SHIELDALLOY METALLURGICAL CORPORATION

June 30, 2006

Re: Follow-up to the March 9, 2006 Meeting and Response to USNRC Letter of January 26, 2006

ATTACHMENT I
SMC Response to the USNRC's letter of January 26, 2006

FIGURE 18.8
ENGINEERED BARRIER
CONSTRUCTION DETAILS

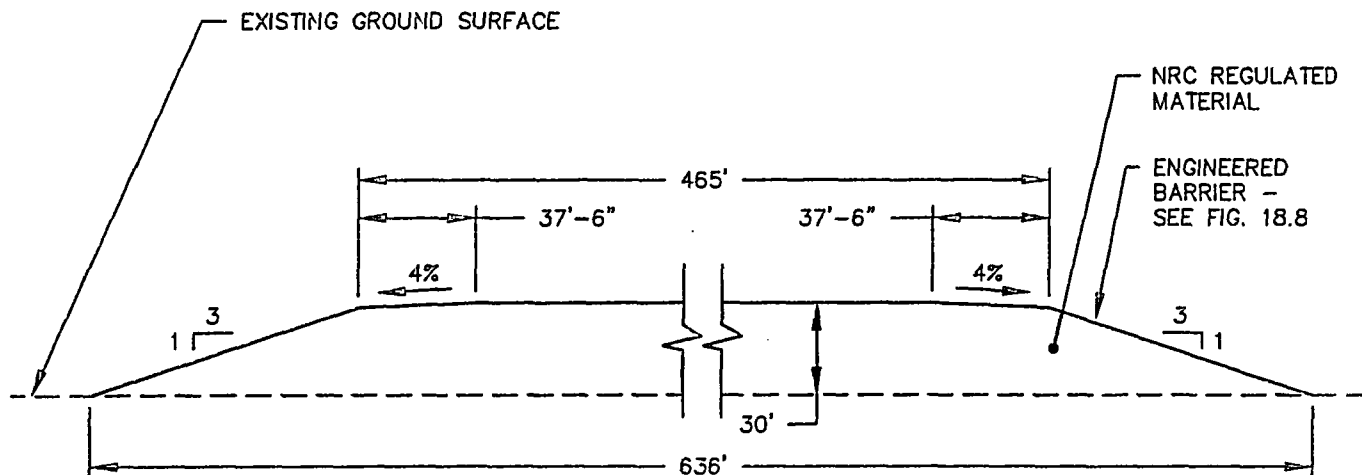
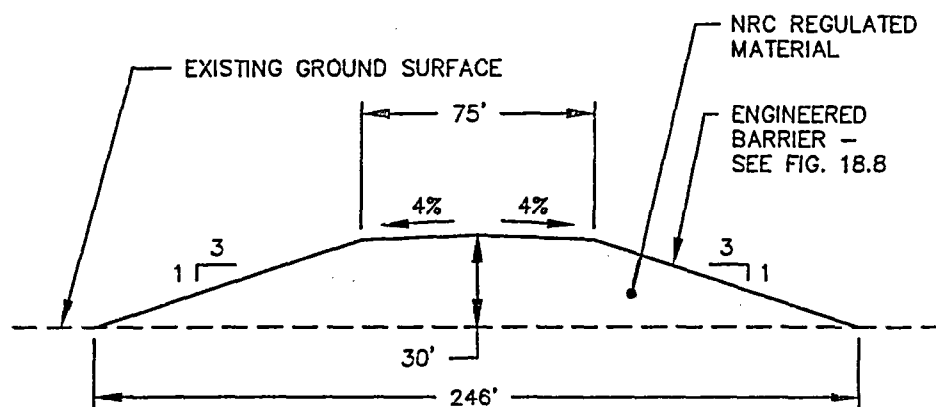
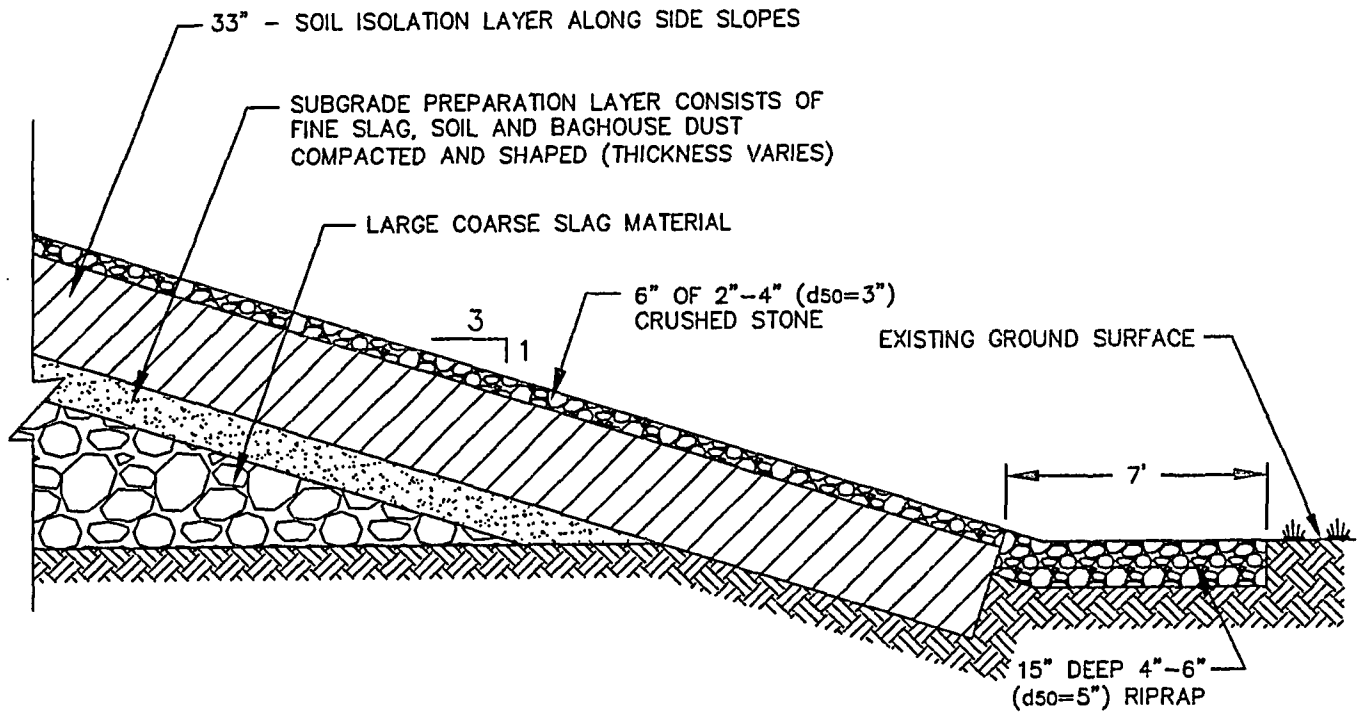
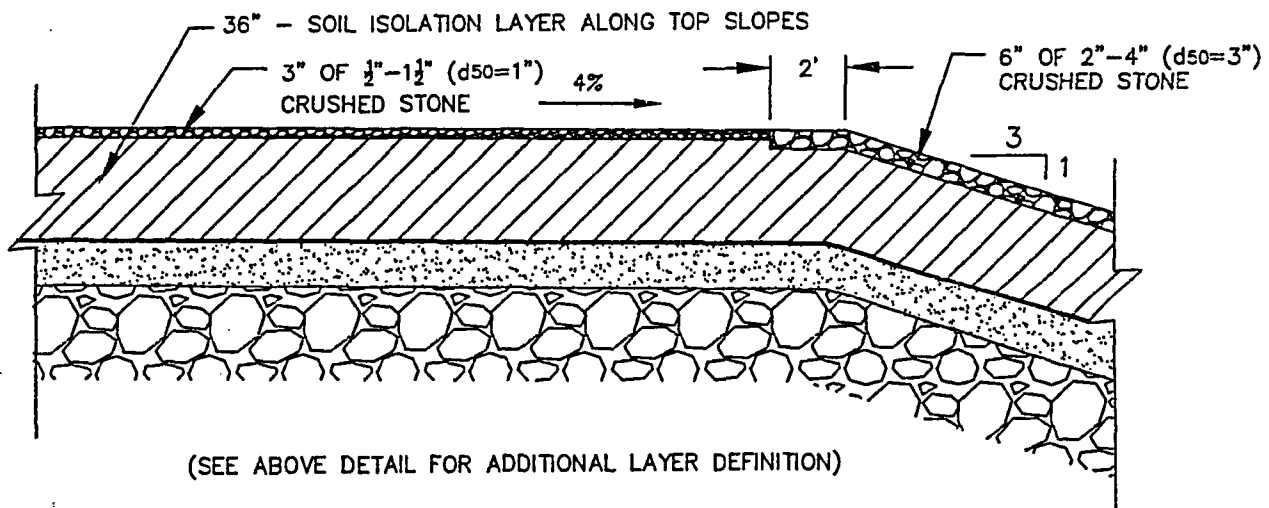
Figures 18.6, 18.7, 18.8 and 18.9 also required revision to reflect the new engineered barrier design. Appendix G of this document contains the revised figures. Figures 18.6 through 18.9 that currently exist in all USNRC copies of the DP should be removed and replaced with the figures in Appendix G in order to upgrade them to Rev. 1a.

Action to be Taken: See action to be taken with respect to Issue No. 7. The need for rock to be placed on the side slopes has been evaluated within the new analyses and more conservative design factors have been incorporated. Rock has been incorporated into the new engineered barrier design and separate evaluations are presented for the top slope, the side slope and the toe of the side slopes. See the Appendices referenced in the response to Issue No. 7 above for the revised evaluations.

Action to be Taken: See actions to be taken with respect to Issues No. 7 and 8. With the incorporation of a new engineered barrier design that includes the placement of rock on the top and side slopes as well as the toe of the side slopes, the accompanying engineering evaluations conducted in accordance with NUREG-1623 guidance demonstrate the protectiveness of these features, even without continued monitoring and maintenance. These revised evaluations clearly demonstrate the robustness of the engineered barrier.
